Subdivision Development in H.O. - G.S.A. Bldg

Item # 65-76

Petitioner LCA COMPANY

Preliminary Review Agencies Comments

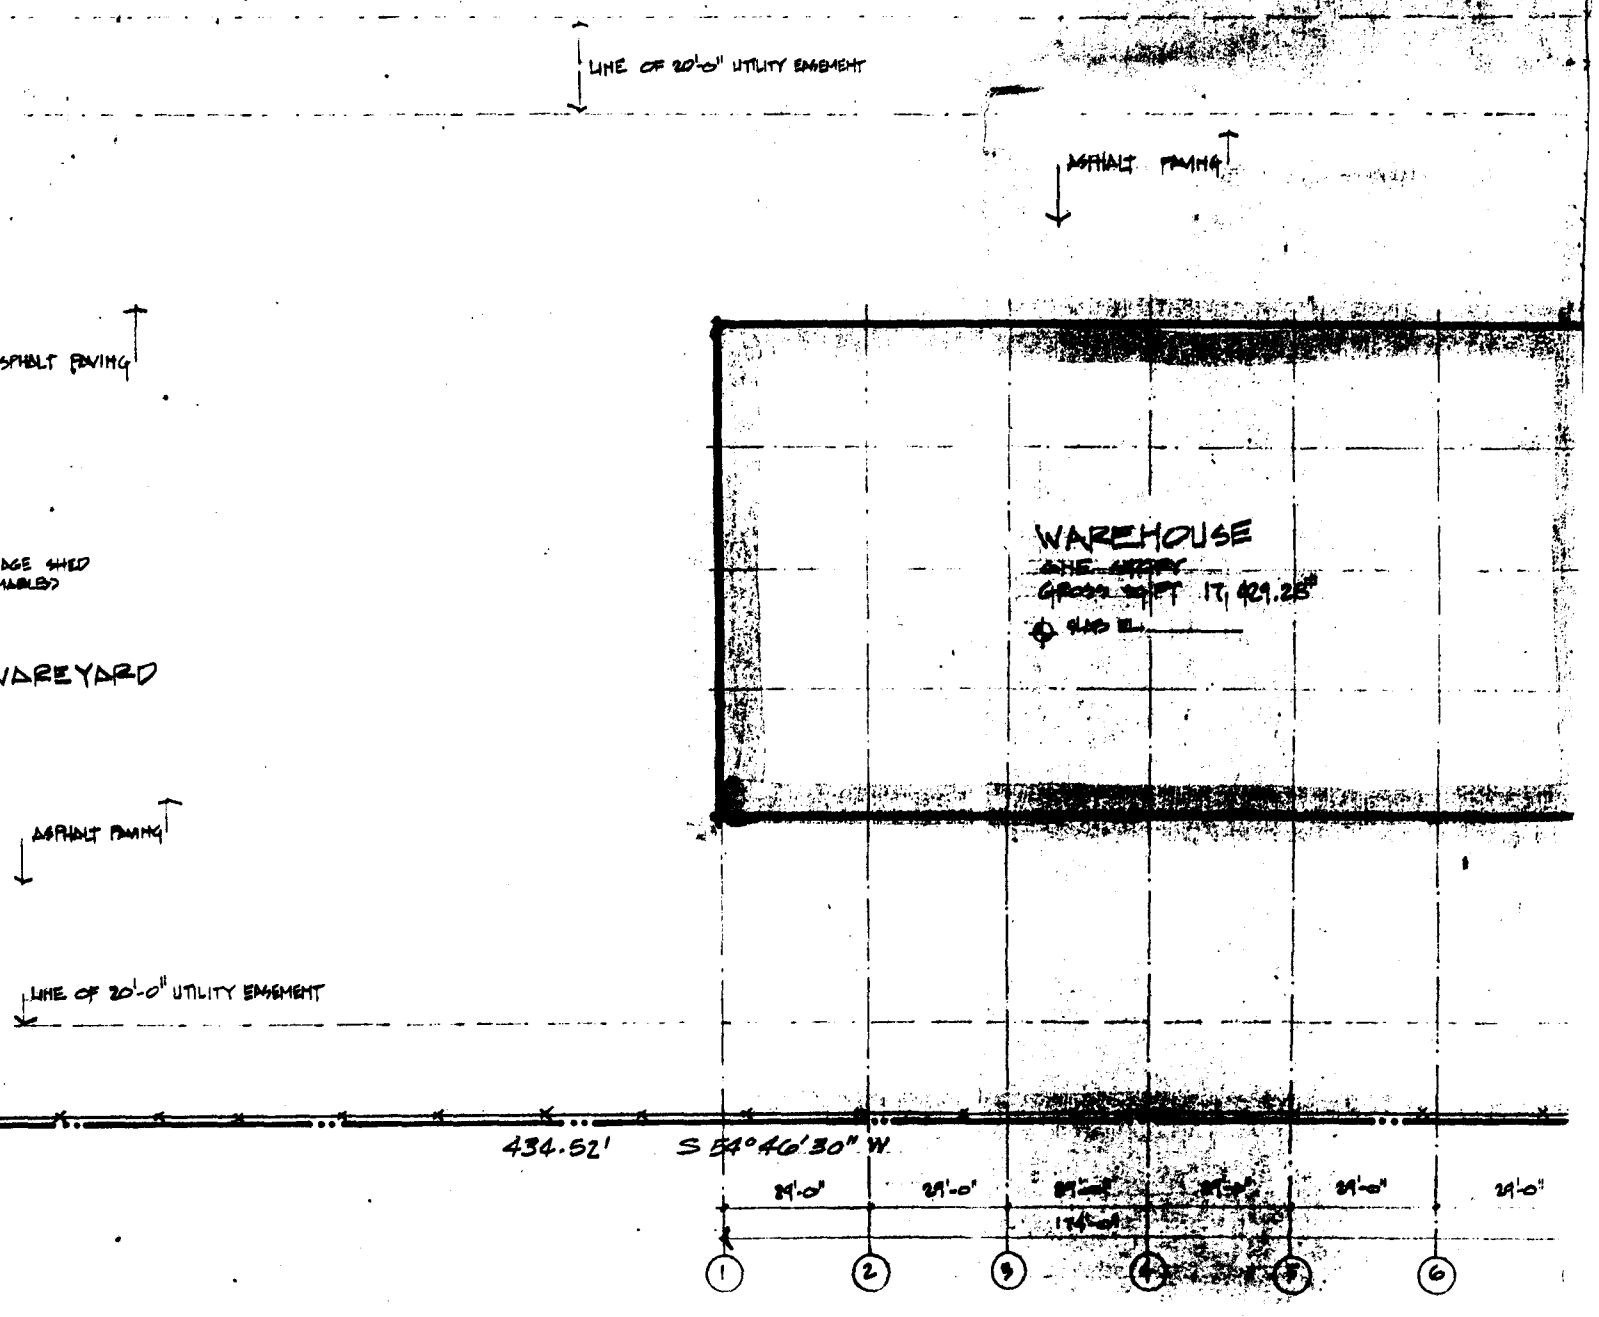
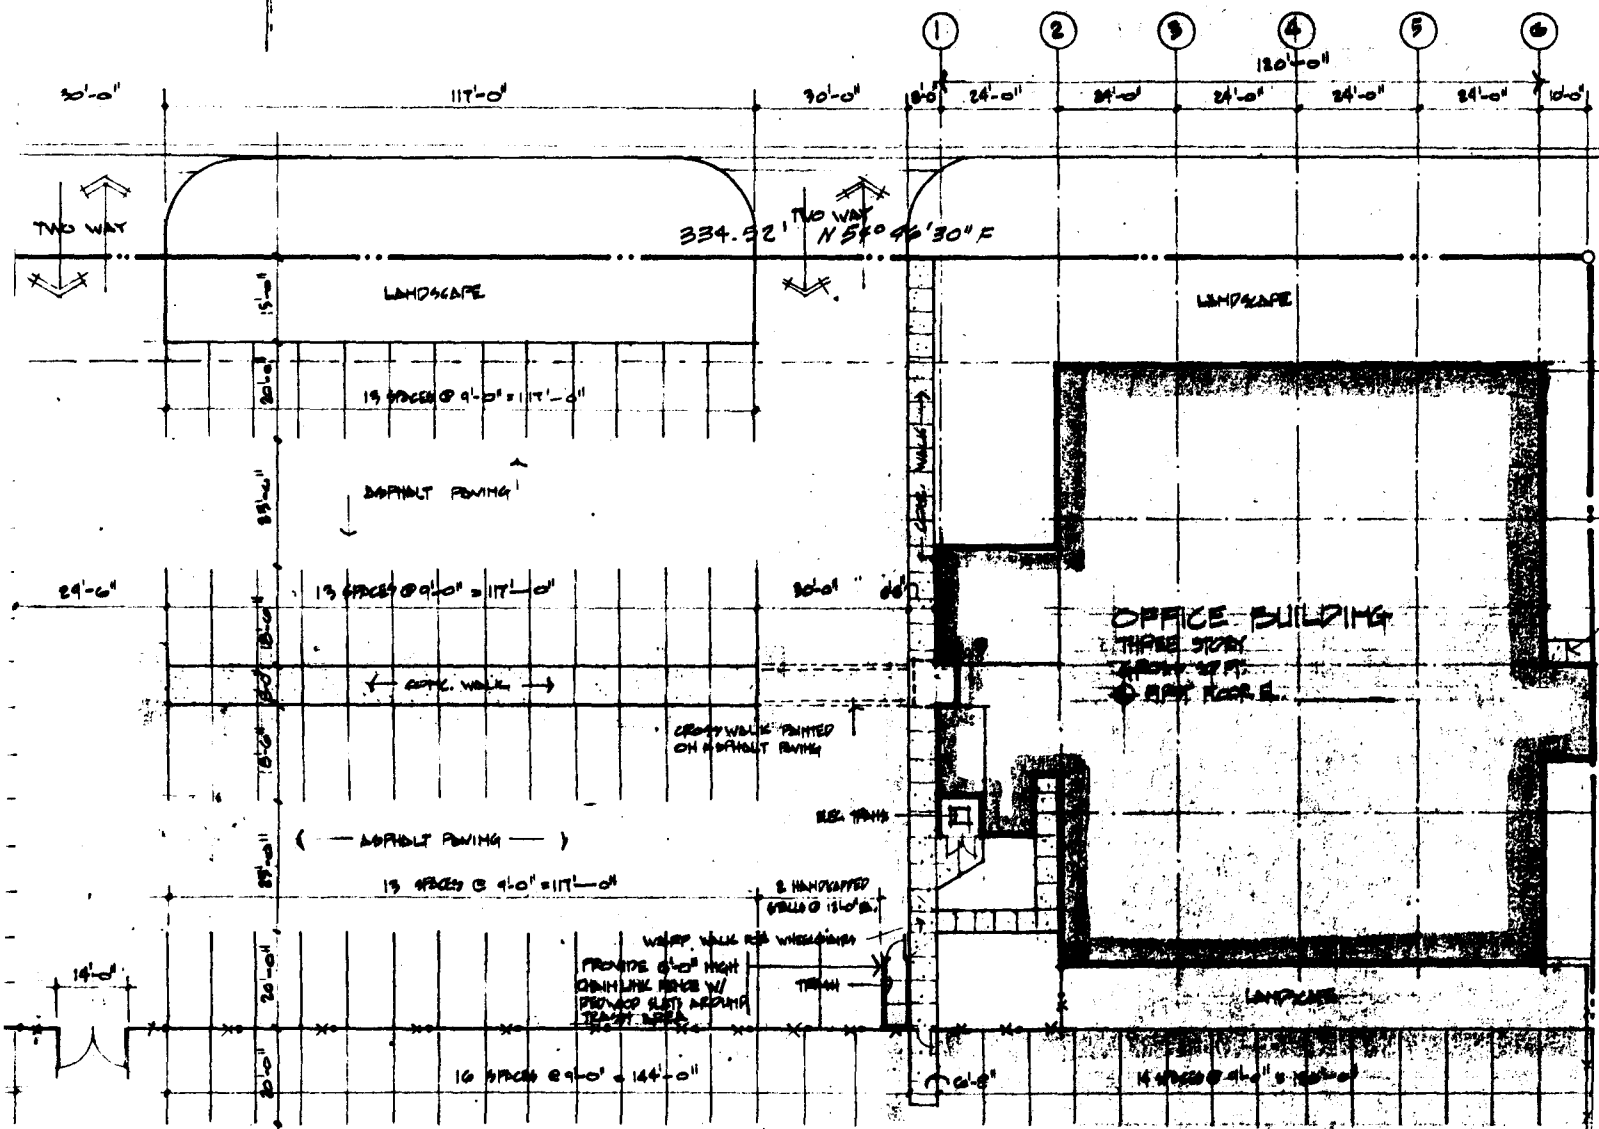
PARKS & REC - recommend the elimination of cottonwoods & chgs in planting distances

ENG - DRAINAGE should be towards Horizon Dr. Get Power of Atty for improvements on Horizon Dr.

Fire Dept. - recommends 1 hydrant at each parking lot entrance (not less than 6" pipe.)

Subject To 15' building setback on east w. landscaping + Eng. & Parks requirements.

Power of Atty for imp. along horizon

P.C. Approved 29 Sept. 1976

C.C. Approved 6 Oct 1976
